# MONUMENT SMALL ENGINE STORAGE AMENDED SITE DEVELOPMENT PLAN

WITHIN A PART OF THE NORTHEAST QUARTER, SECTION 15,  
TOWNSHIP 11 SOUTH, RANGE 67 WEST OF THE 6th P.M.  
COUNTY OF EL PASO, STATE OF COLORADO

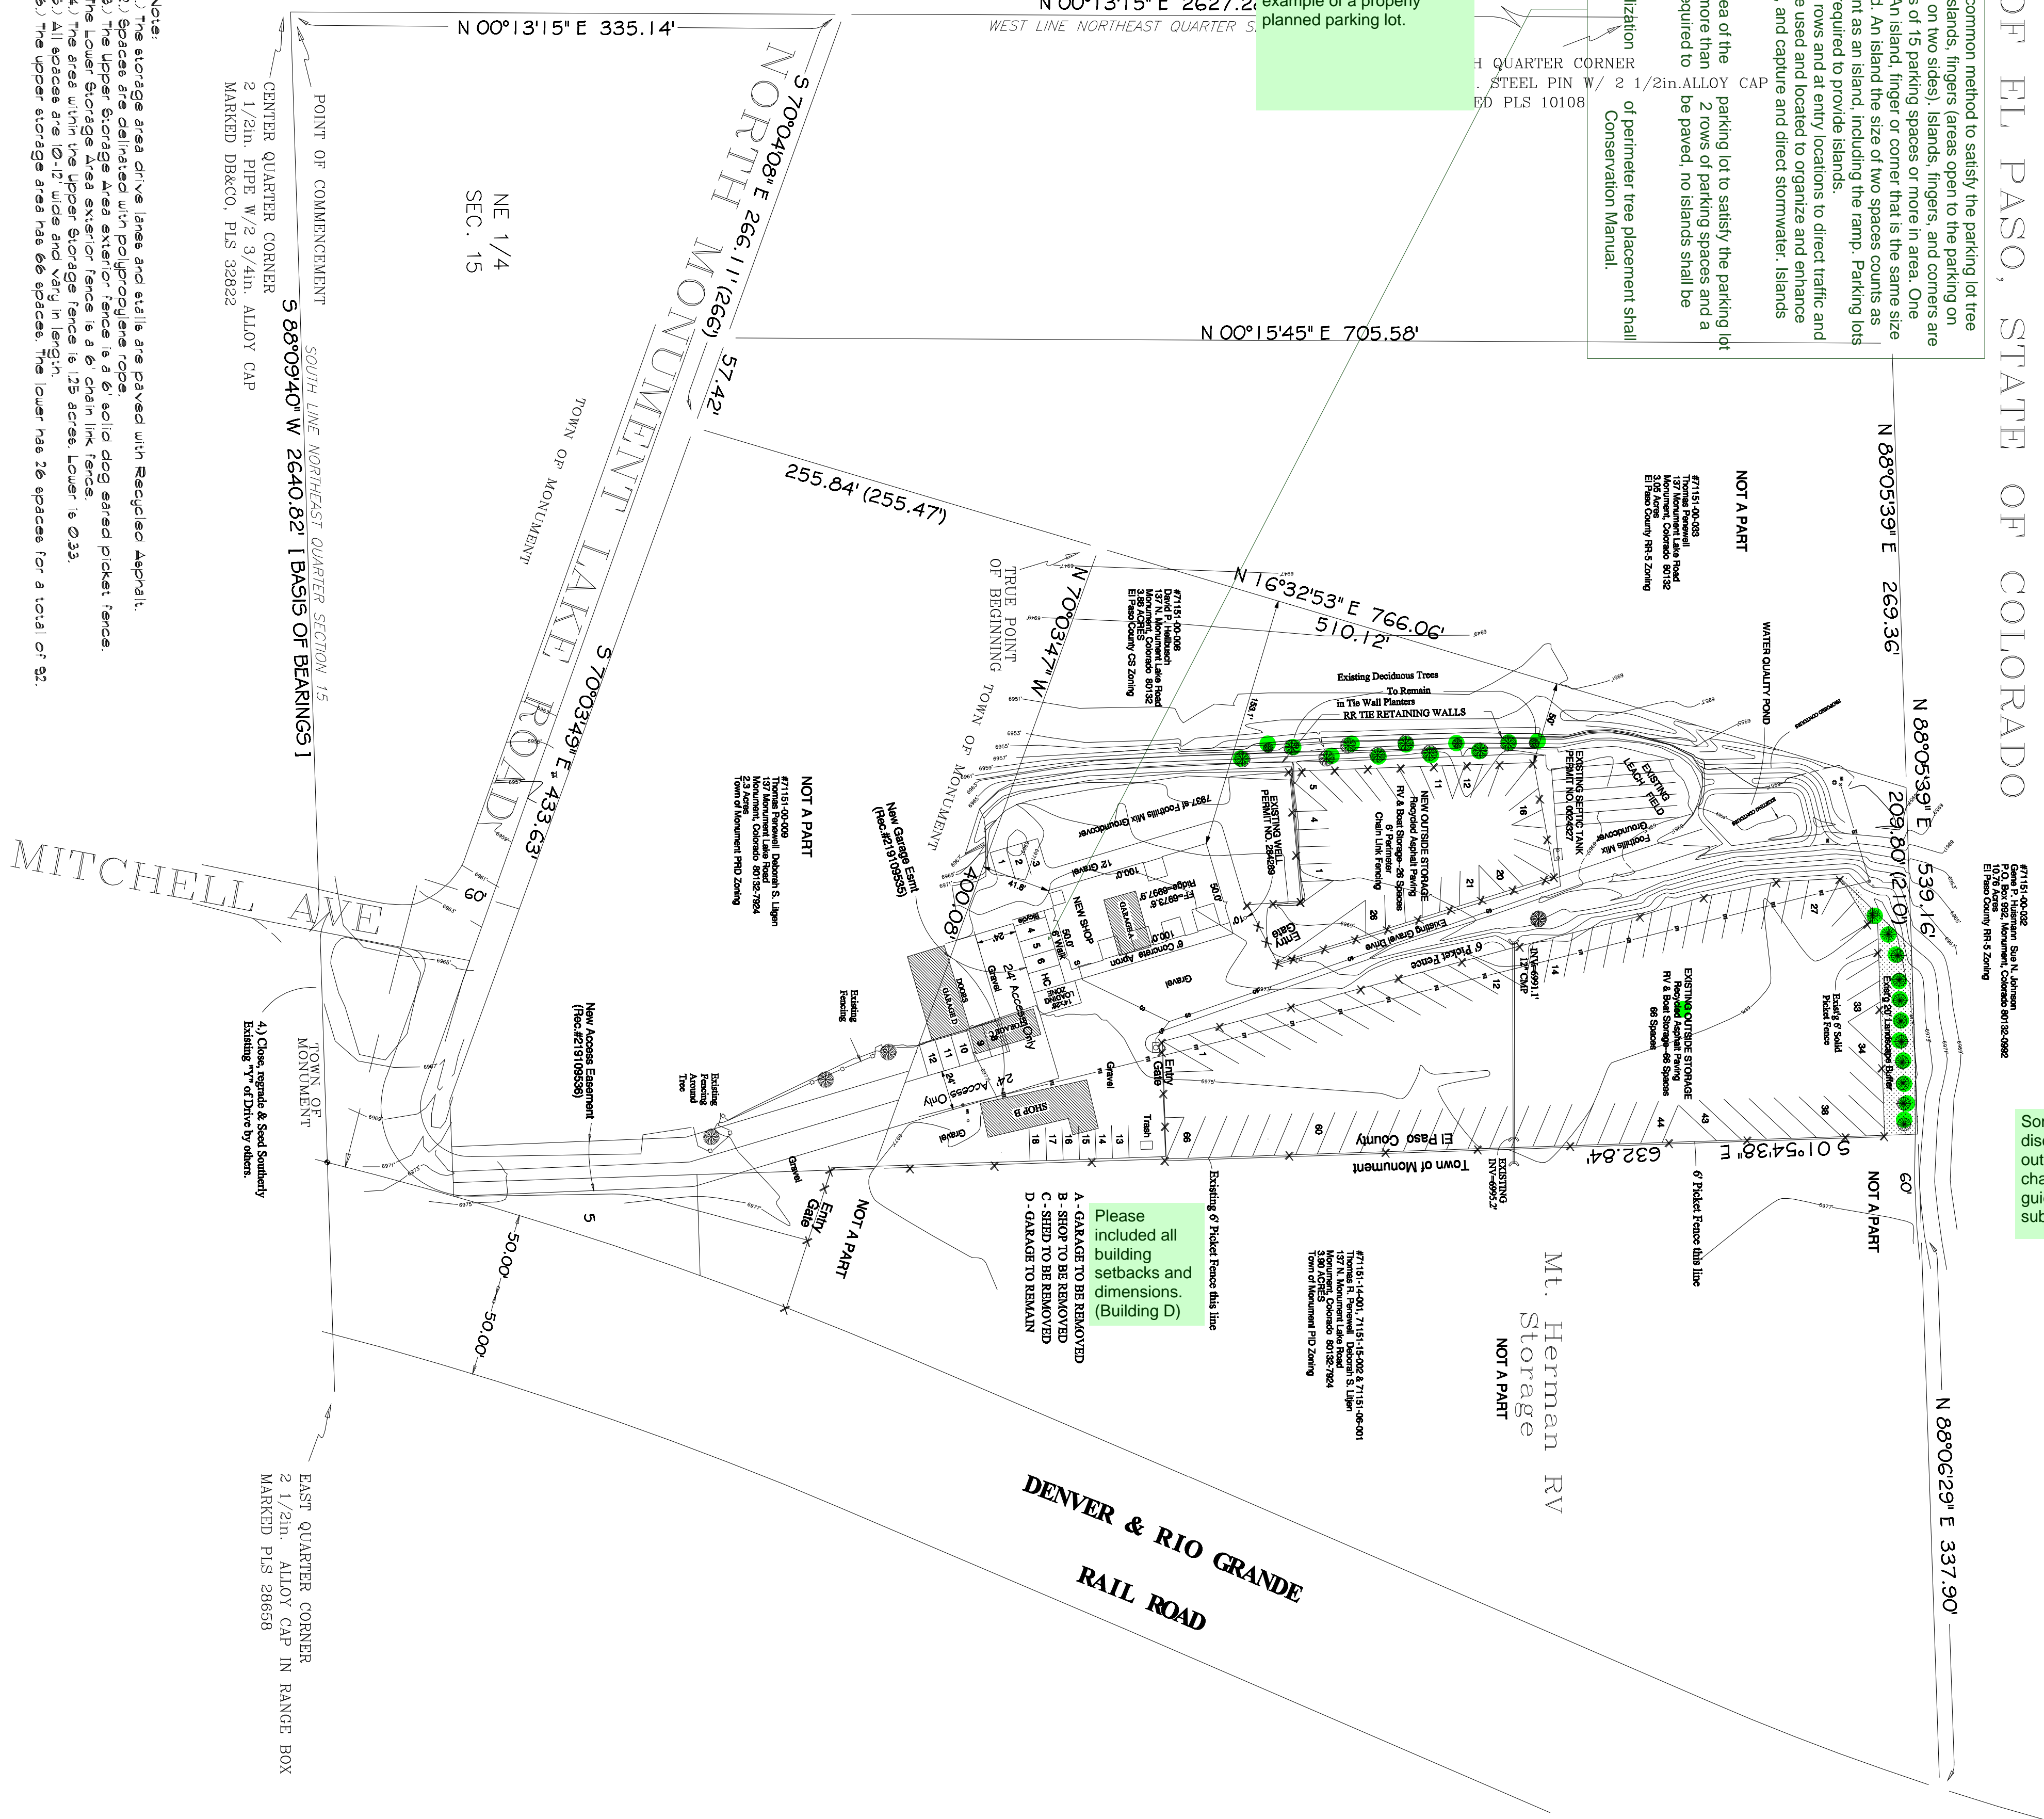
Please include parking detail showing dimensions of parking stalls and parking calculations. This plan does not use islands correctly nor does it have them landscaped. The parking lot configuration will not be approved as is. Please revise for safety and to meet the standards above. Using EDARP to review previously approved projects may be useful. PPR-20-002 is a good example of a properly planned parking lot.

6.2.2 (2) - (2) Parking Lot Islands - The most common method to satisfy the parking lot tree requirement is through the utilization of plant islands, fingers (areas open to the parking on three sides), and corners (open to the parking on two sides). Islands, fingers, and corners are required to be incorporated into all parking lots of 15 parking spaces or more in area. One island shall be provided for every 15 spaces. An island, finger or corner that is the same size as a parking space counts as a required island. An island the size of two spaces counts as two islands. Pedestrian entry spaces also count as an island, including the ramp. Parking lots containing fewer than 25 spaces shall not be required to provide islands. Islands should be located at the end of center rows and at entry locations to direct traffic and minimize cutovers. Islands should generally be used and located to organize and enhance circulation, breakup continuous parking areas, and capture and direct stormwater. Islands protect vegetation from damage.

Small parking lots may utilize the perimeter area of the parking lot to satisfy the parking lot tree location requirement when there are not more than 2 rows of parking spaces and a single drive aisle. Where a parking lot is not required to be paved, no islands shall be required.

The tree types, minimum planter sizes and utilization of perimeter tree placement shall be consistent with the Landscape and Water Conservation Manual.

The following note should be added to all site development plans or non-residential site plans, as applicable, prior to PCD approval: The parties responsible for this plan have familiarized themselves with all current accessibility criteria and specifications and the proposed plan reflects all site elements required by the applicable ADA design standards and guidelines as published by the United States Department of Justice. Approval of this plan by El Paso County does not assure compliance with the ADA or any regulations or guidelines enacted or promulgated under or with respect to such laws.

Some of the larger discrepancies have been outlined but review full chapter 6 development guidelines for a full submission

Please include all building setbacks and dimensions. (Building D) A - GARAGE TO BE REMOVED B - SHED TO BE REMOVED C - SHED TO BE REMOVED D - GARAGE TO REMAIN
